# Safety Policy Division Evaluation Report on PG&E 2024 RAMP Application (A.)24-05-008

November 8, 2024

**California Public  
Utilities Commission**

Figure 1-3: Relationship between cumulative wildfire risk reduction and cumulative circuit miles of risk reduction activity<sup>58</sup>

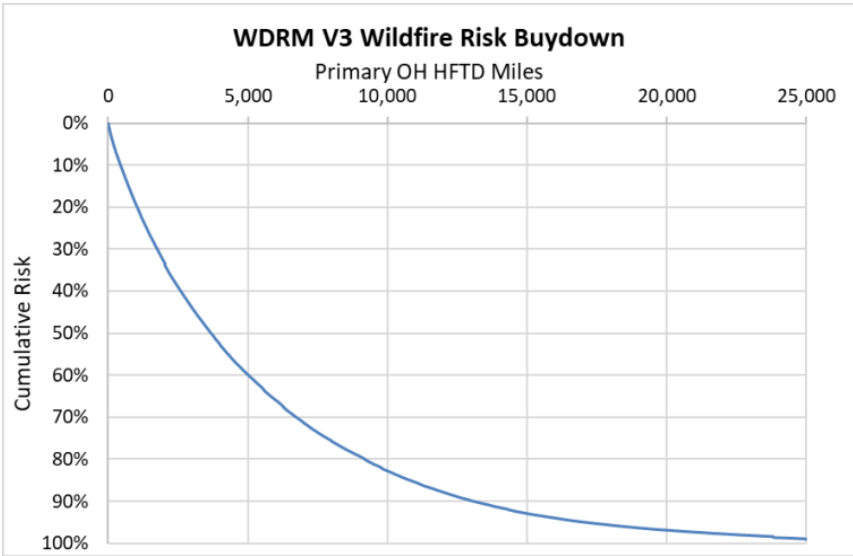
Figure 1-3 is plotted based on the Baseline Data spreadsheet in the “EO-WLDFR-18 WDRM V3 Risk Buydown.xlsx” workpaper. PG&E provides risk scores calculated using WDRM V3<sup>59</sup> for each circuit segment but does not clearly explain how it assigned circuit segments to risk-based tranches. SPD created Table 1-2 below with selected circuit segments to highlight this issue. SPD calculated the risk-per-mile (risk/mile) values using PG&E’s risk and mileage data.<sup>60</sup> As shown in Table 1-2 below, SPD finds no discernable correlation between the risk/mile values and PG&E’s assigned tranches. SPD provides more detailed analyses on this issue in the Tranche observations section.

Figure 1-8: Differences in the calculated risk in PG&E's risk models for circuit segments which PG&E proposed any mitigation in 2024 RAMP.<sup>129, 130</sup>

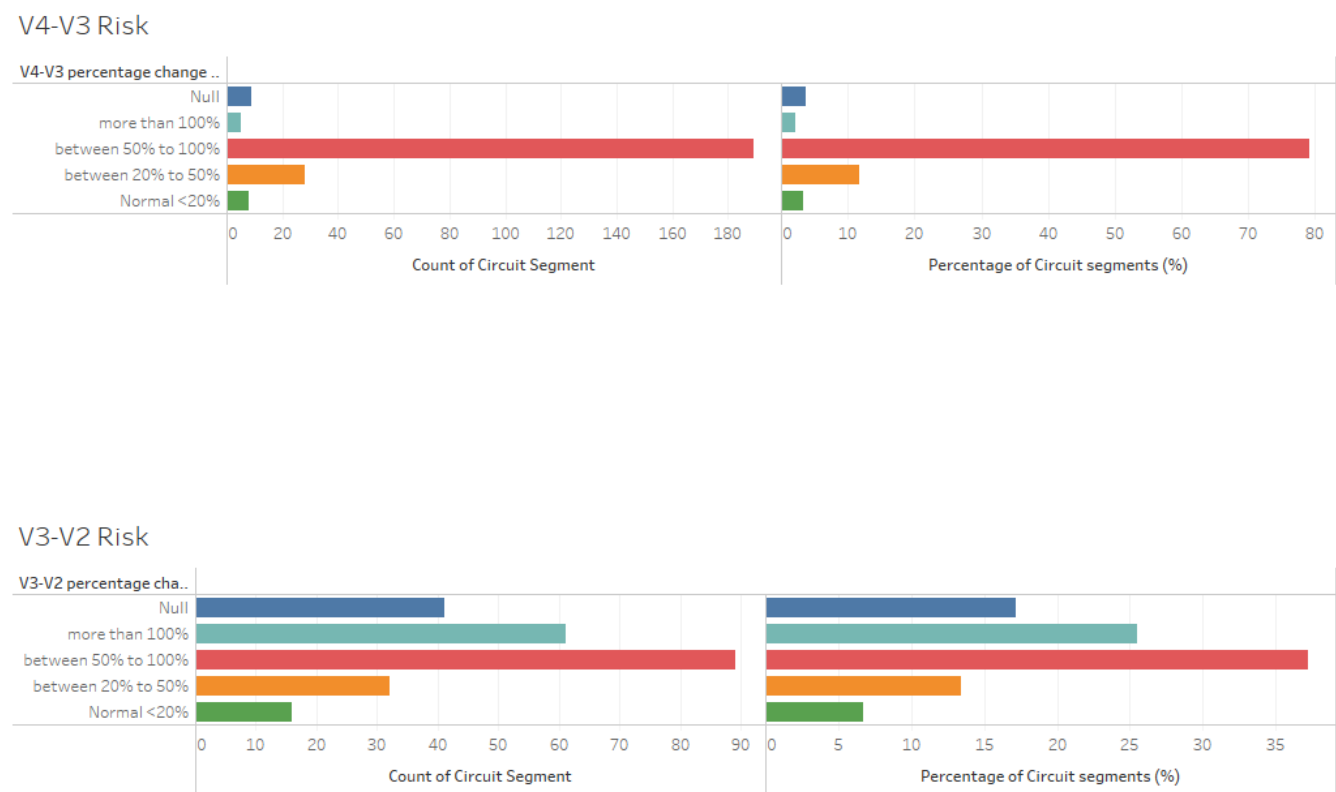
To clarify this issue further, SPD issued a data request<sup>127</sup> to PG&E to provide more information regarding differences in the calculated risk and miles in PG&E's risk model versions 3 and 4 for all circuit segments, where PG&E proposed implementing any mitigations in its 2024 RAMP. SPD analyzed the changes in calculated risk, at the circuit segment level, between PG&E's model versions and presents the results in Figure 1-8 below. The upper part of the graph (V4-V3) shows the changes from version 3 to version 4 and lower part of the graph (V3-V2) shows the changes from version 2 to version 3. The dark blue bars, "Null" in all four graphs, identify whether a circuit segment doesn't exist in the older or newer version of the model. SPD finds that although the percentage of changes in calculated risk and circuit segment names from V4 to V3 are less pronounced when compared to the previous version update (i.e., from V3 to V2), 92 percent of the calculated risk in circuit segments changed by more than 20 percent from V3 to V4.<sup>128</sup>

Figure 1-6: PG&E's circuit segment length change in different risk models<sup>131</sup>.

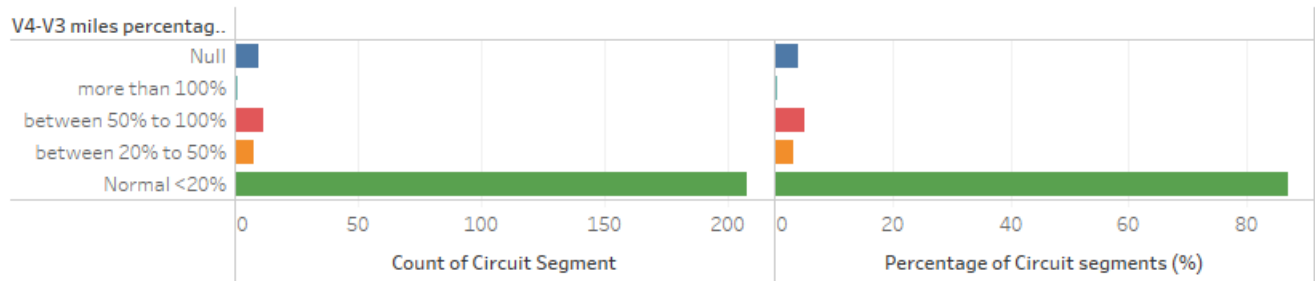
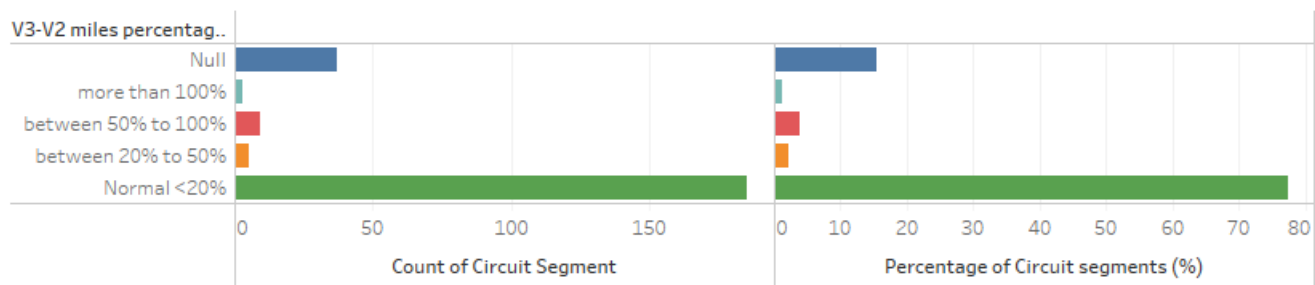
SPD further analyzed PG&E circuit segment length (mile) changes between WDRM risk models, as presented in Figure 1-9. This illustrates how PG&E changed the length of some circuit segments from one risk model to the next. SPD finds that, although changes in the length of circuit segments for most circuits are less than 20 percent (e.g., 87 percent of circuit segment length changes from V3 to V4 are within the 20 percent range), almost 10 percent of circuit segment lengths changed by more than 20 percent. SPD recommends that PG&E explain why a circuit segment in the proposed mitigation plan in the 2024 RAMP (using V3) has more than a 20 percent change in length (mileage) when reported in the TY 2027 GRC (using V4).

Figure 5-1 – PG&E's Electric Transmission Systemwide Blackout Risk Bow Tie

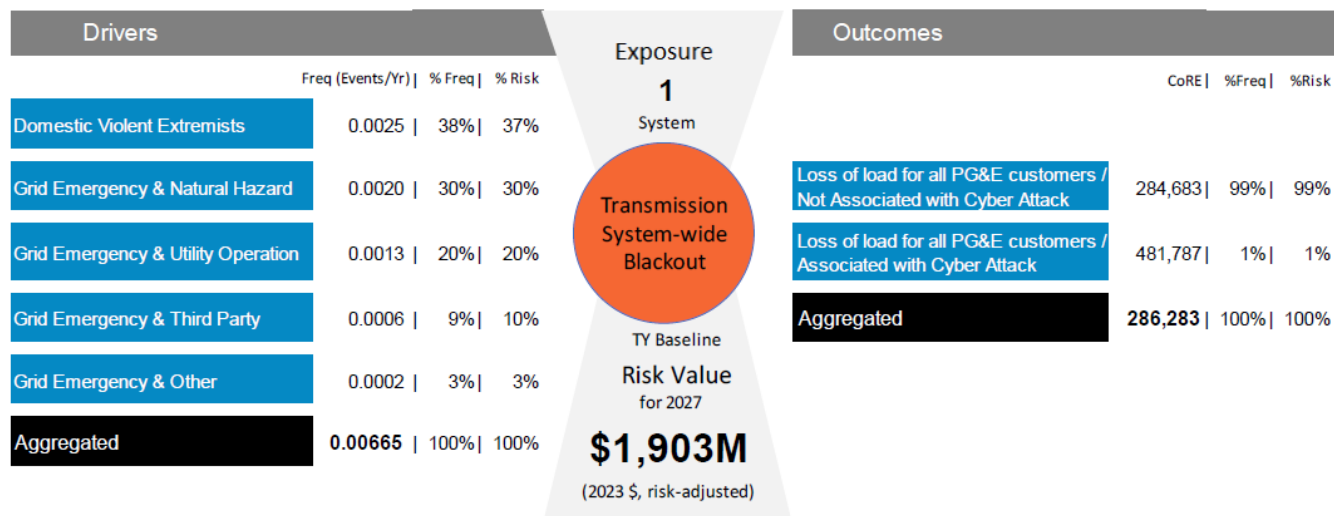
SPD finds that aggregated Frequency (Events/Yr) for Drivers of 0.00655 multiplied times aggregated Outcomes (CoRE) of 286,283 equals \$1,903M shown in Figure 1, PG&E's Electric Transmission Systemwide Blackout Risk Bow Tie.

Figure 8-2: Risk Bow Tie<sup>262</sup>

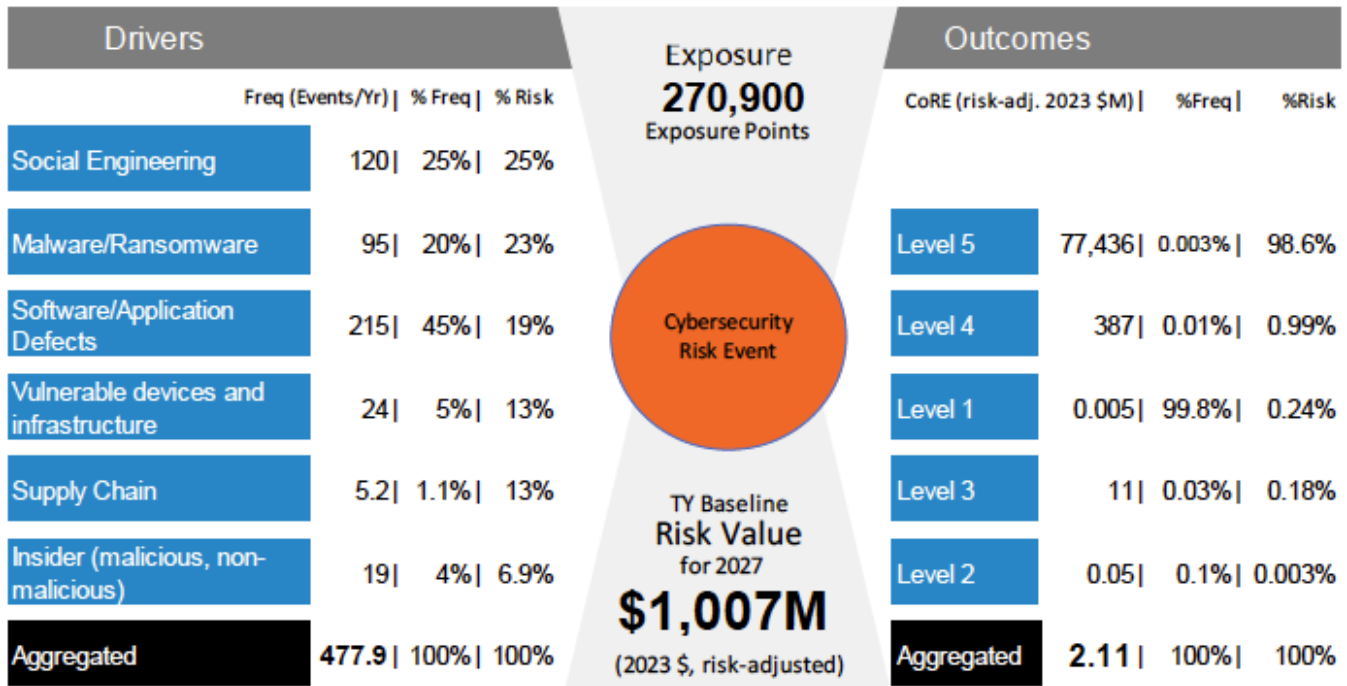
PG&E’s exposure to cybersecurity risk is measured in Units of Exposure or Exposure Points. The total number of exposure points is calculated at 270,900 (Figure 8-2 above). Threat actors' capabilities and motivation for cyber-attacks continue to increase as new technology develops.<sup>263</sup>

Figure 10-5: Tranche-level CBR Values for DUNGD-C006 Primary Cable Replacement<sup>399</sup>

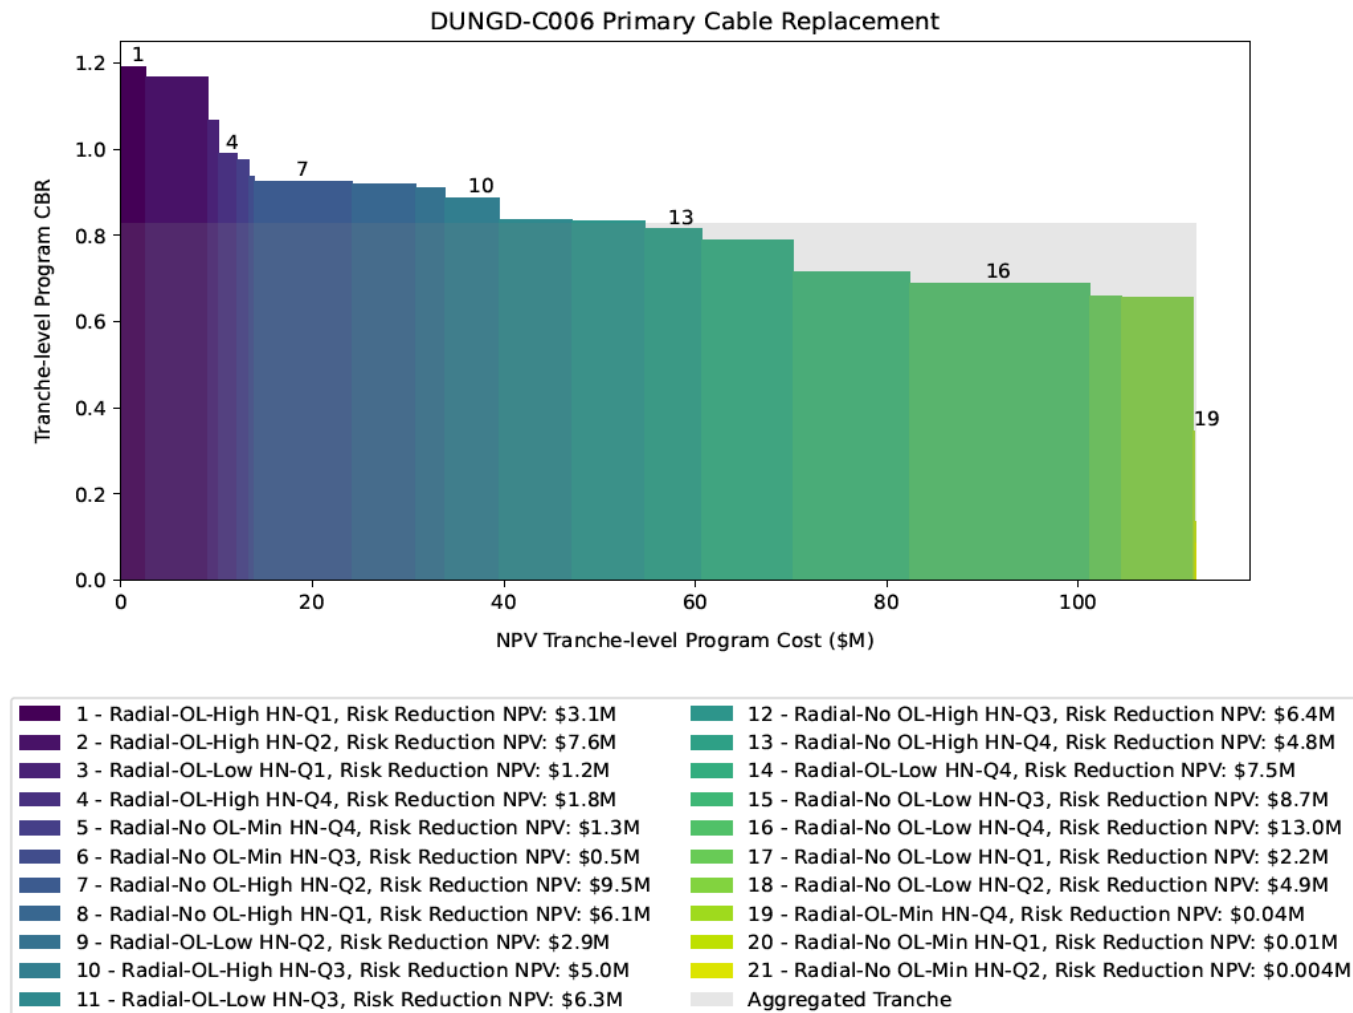
**DUNGD-C006:** Figure 10-5 below shows the diminishing CBR characteristic of DUNGD-C006 with only Tranches 1, 2, and 3 having a CBR of at least 1.0. From a purely cost-benefit analysis perspective without other considerations, primary cable replacement work in the DUNGD-C006 control program should only be performed on the top three riskiest tranches shown in Figure 10-5. Figure 10-5 does not capture possible non-CBR justifications for expanding mitigation work to tranches below the CBR=1.0 threshold. Such justifications could conceivably include, for example, risk tolerance, minimum asset replacement rate considering the age and expected remaining life expectancy of the assets, contractual obligations, the desire to achieve a lower unit cost with a higher volume of work, possible compliance requirements, concurrent mitigation work with other mitigation activities, and others. However, PG&E presented no such justifications.

Figure 10-6: Tranche-level CBR Values for DUNGD-C007 LBOR Switch Replacement<sup>400</sup>

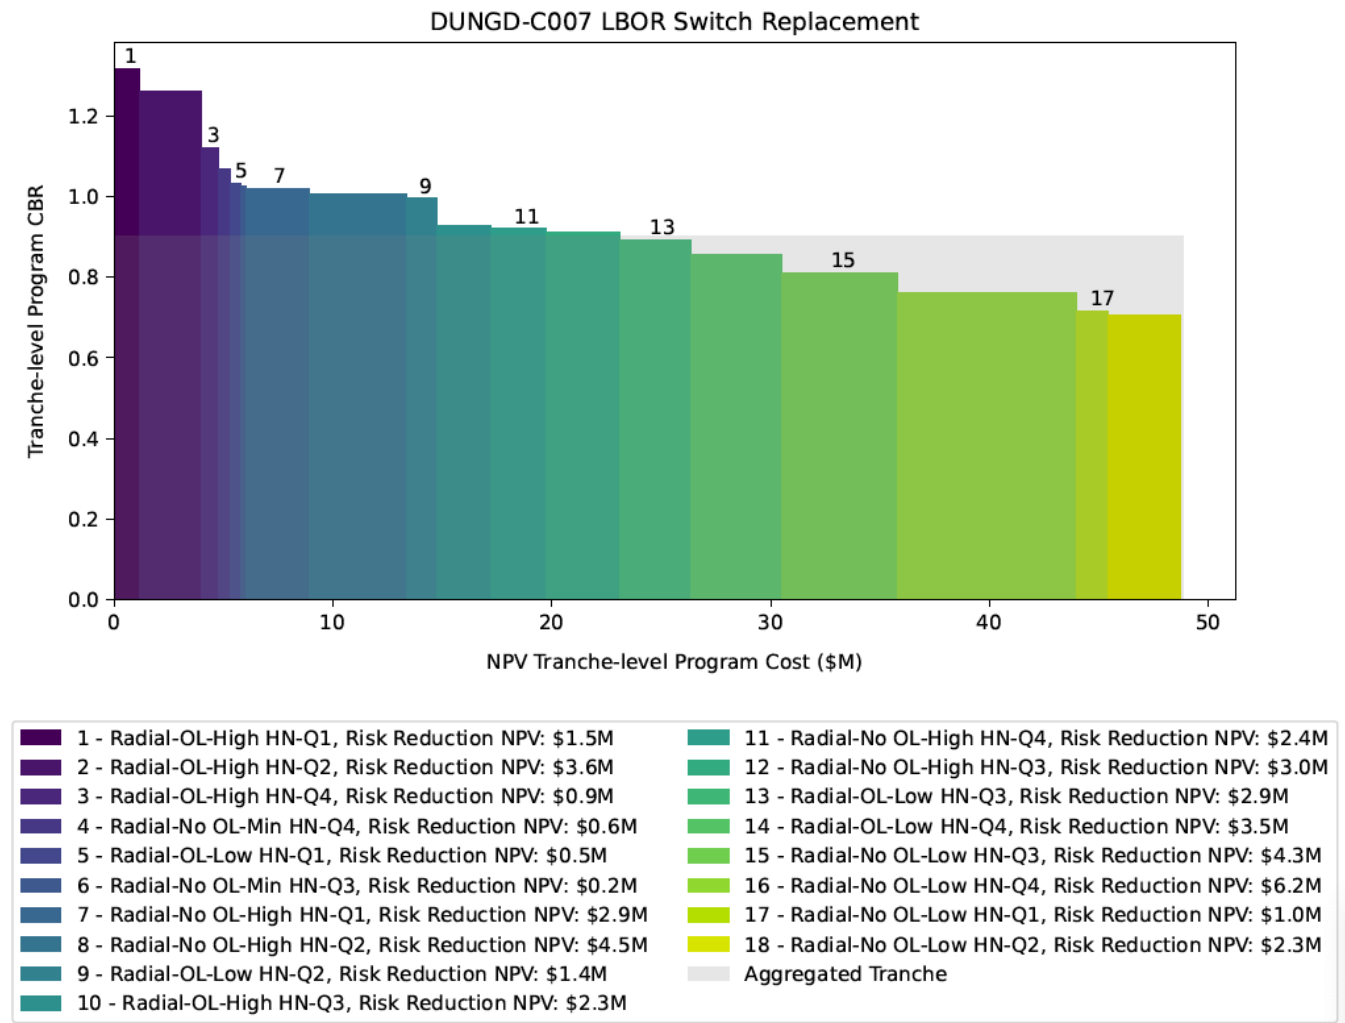
**DUNGD-C007:** For the DUNGD-C007 LBOR (Transformer Load-Break) Switch Replacement control program, Figure 10-6 shows the tranche-level CBR values. Figure 10-6 shows that only the top 9 riskiest tranches in this control program have a CBR greater than or equal to 1.0. From a cost-benefit perspective, LBOR switch replacement work should only be performed on the top 9 riskiest tranches. Again, Figure 10-6 does not capture possible non-CBR justifications for performing LBOR switch replacement work for tranches with a CBR less than 1.0.

Figure 10-7: Tranche-level CBR Values for DUNGD-C014<sup>401</sup>

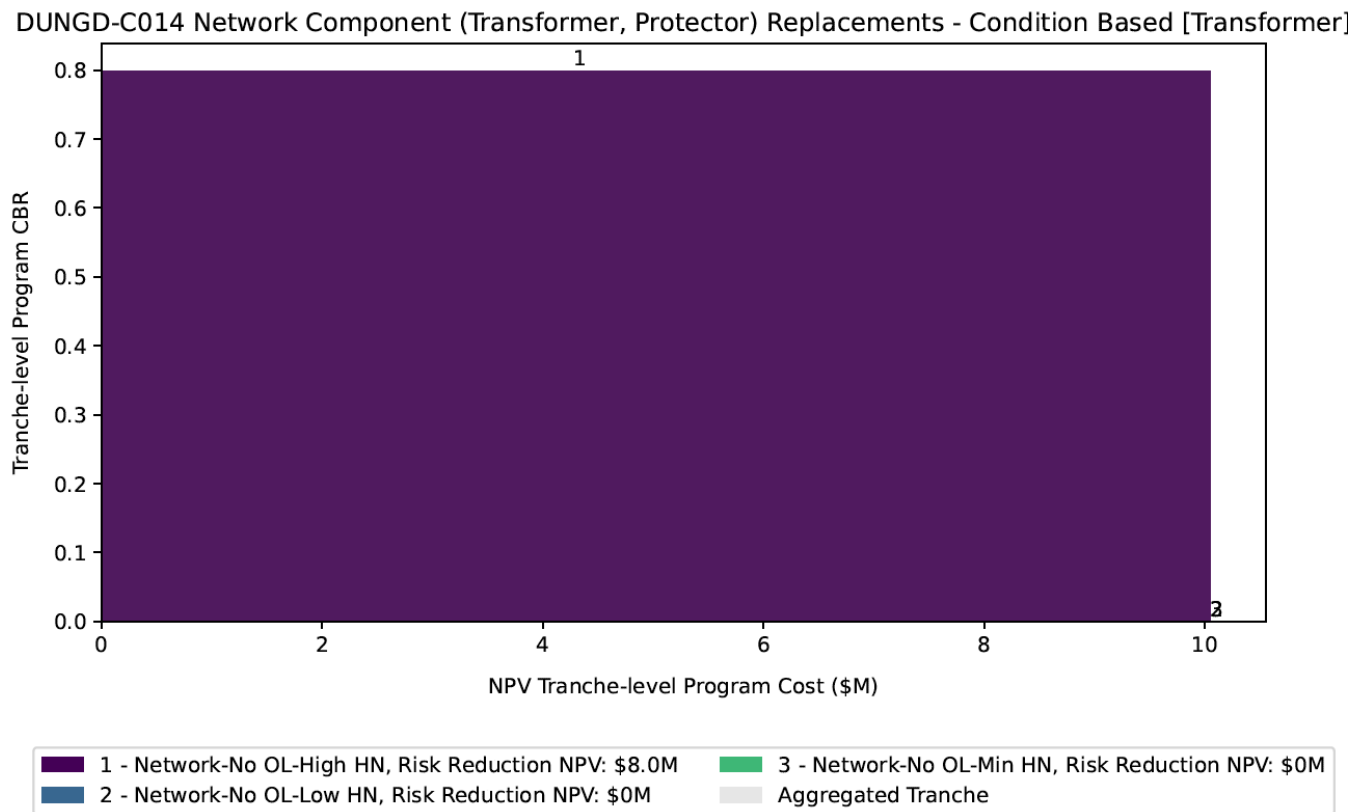
**DUNGD-C014:** Figure 10-7 shows the tranche-level CBR values for the DUNGD-C014 control program, an asset condition-based transformer replacement program covering the Oakland/San Francisco downtown network systems. The program CBR is 0.8, and there is no tranche in which the CBR is above 0.8. The CBR of 0.8 calls into question whether this control program should be funded for the 2027 to 2030 GRC period at all. PG&E states that transformers are usually replaced (in DUNGD-C014) at the same time as network protectors (in DUNGD-C015). There could be other considerations and justifications that PG&E did not present in the 2024 RAMP that would justify this program despite the CBR being less than 1.0.

Figure 10-8: Tranche-level CBR Values for DUNGD-C015<sup>403</sup>

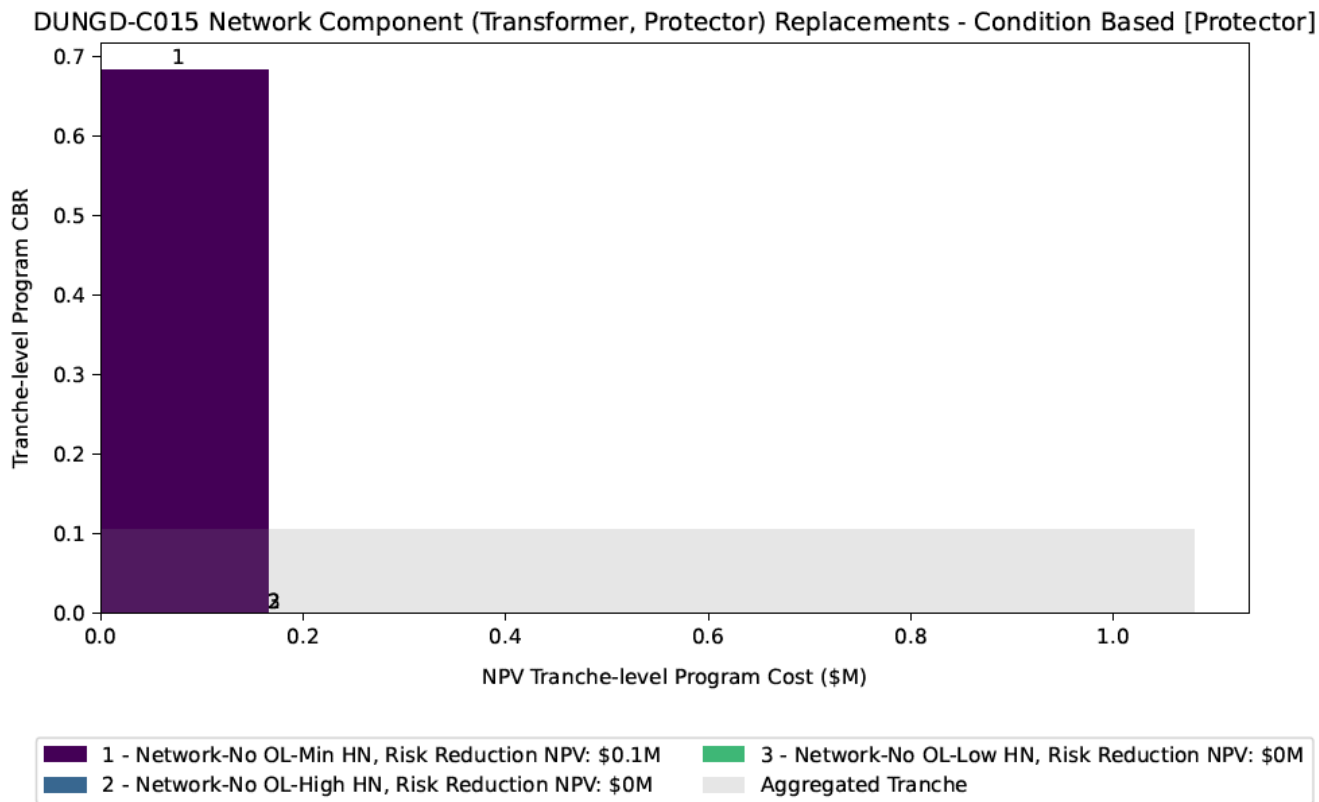
**DUNGD-C015:** Figure 10-8 shows the tranche-level CBR values for the DUNGD-C015 control program, an asset condition-based replacement program of network protectors in the Oakland/San Francisco downtown network systems. The description for DUNGD-C015 states that “this control addresses potential transformer or protector failures. It reduces the UG Network Equipment Failure driver, which includes reducing the consequence of an explosion, smoke, or fire event.”<sup>402</sup> Based on this description, DUNGD-C015 is not a compliance-based (i.e., mandatory) activity. It has an aggregate CBR of 0.1. PG&E states that network protectors (in DUNGD-C015) are usually replaced at the same time as transformers (in DUNGD-C014). Since both DUNGD-C014 and DUNGD-C015 have a CBR less than 1.0 at the program level and at any tranche level, it calls into whether additional justification is needed to warrant their funding

in the 2027 to 2030 GRC period. As controls, both programs are continuations of existing programs. However, that does not mean they should be automatically approved for continued funding in the 2027 to 2030 GRC period, regardless of their low CBRs. Once again, there could be other considerations that PG&E did not present, which could justify their continued funding for 2027 to 2030. PG&E should provide additional information and/or additional justifications for these two controls in the GRC application.
